RESOURCE CONSENT APPLICATION
LOT 23 BLK VI, LINKWATER, OHINGAROA BAY, KENEPURU ROAD
Project Number: P2001-439H, Your Ref: U011119

Resource Consent Application - Request for Further Information

ON-SITE WASTE DISPOSAL REPORT P2001 439H

Date: Sept. 2001	Eng: MJH	Job No: B2001-427H	Sheet No: APPENDIX C
Project: Lot 23 Blk VI, Linkwater, Ohingaroa Bay, Kenepuru Road

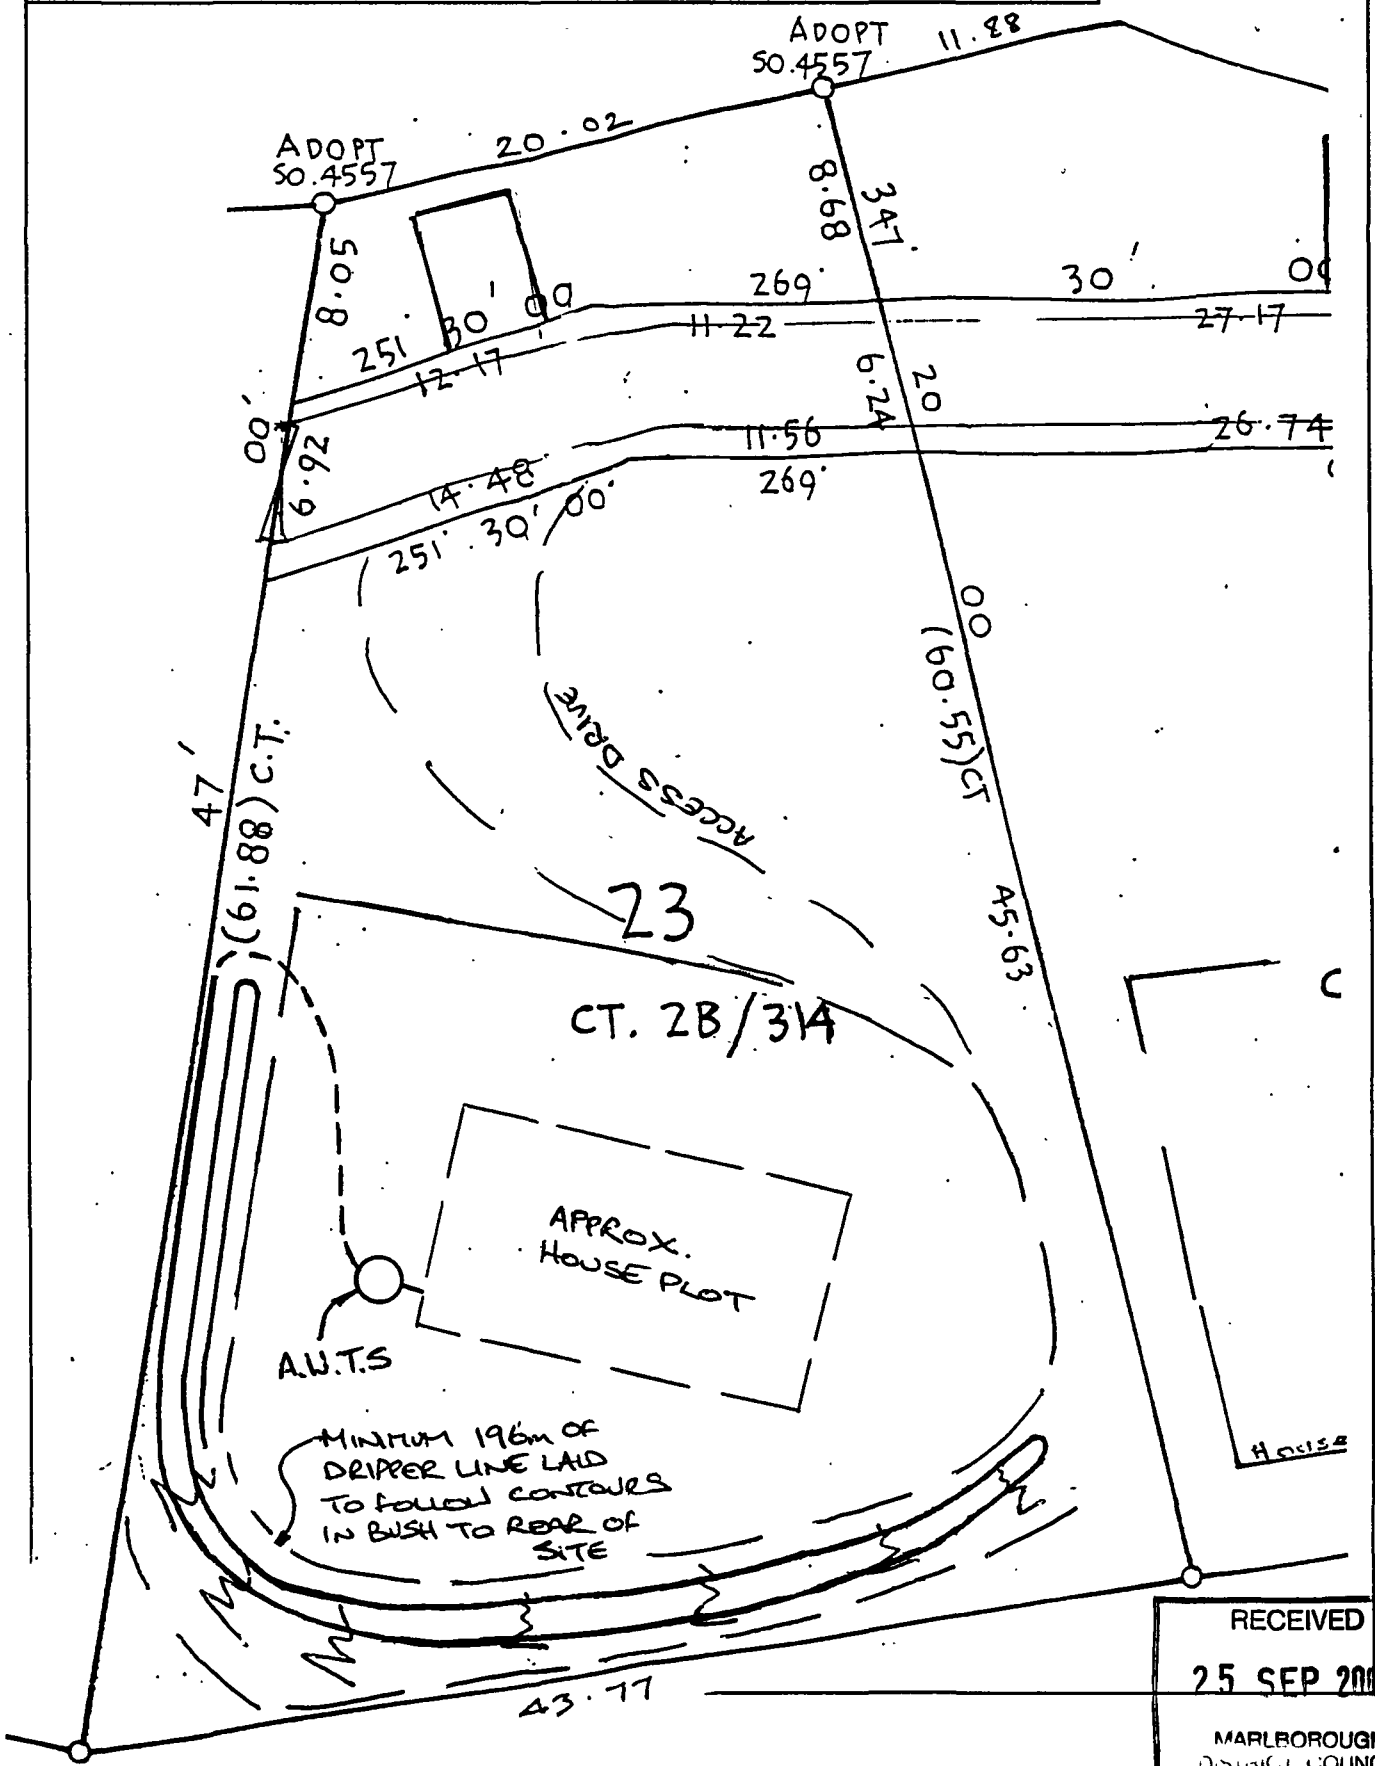
1. An assessment of the adverse effects of the discharge. In particular whether the discharge will initiate any instability or make any existing instability worse.
2. The type of occupancy of the dwelling (ie, intermittent/permanent) and, if possible, a nomination of the AWTS to be used at the site.
3. The total area (as opposed to length) of the wastewater application area, its proximity to property boundaries, and the slope of the land over which the dripper lines are to be laid.
4. The depth at which the dripper lines are to be buried.

3. The total length of dripper line should be no less than 196 metres, with dripper lines spaced at 1m centres to provide a minimum drainage field area of 196m^2 .

The drainage field is situated on the southern side of the site as indicated in Appendix C of our report. The drainage area is close to the boundary but will not affect any adjoining land.

The slope of the land is approximately 20°, the dripper lines are to be laid to follow the horizontal contours of this slope for equal dosing along the line. Shallow subsurface seepage on the slope is restricted by the bush in this area as discussed in item 1.
